UNITED STATES DEPARTMENT OF COMMERCE
Patent and Trademark Office

APPLICATION NO.	FILING DATE	FIRST NAMED INVENTOR	ATTORNEY DOCKET NO.
09/145,982	09/03/98	HASE	T 684.2728

Office Action Summary

☒ This action is FINAL.

Fig.7 of Tanimoto.

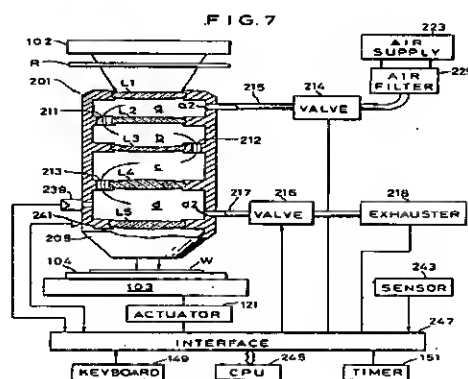
9. Claims 1-2, 4-7, 10-11, 14-16 and 18 are rejected under 35 U.S.C. 102(b) as being clearly anticipated by Tanimoto et al (U.S.Pat. 4,690,528).

With regard to claims 1-2, 4-7, 10-11, 14-16 and 18 Tanimoto et al (fig.1 and 7) disclose an exposure apparatus comprising all of the limitations of the invention as claimed. (see abstract and fig.1, 7 and 8 of Tanimoto).
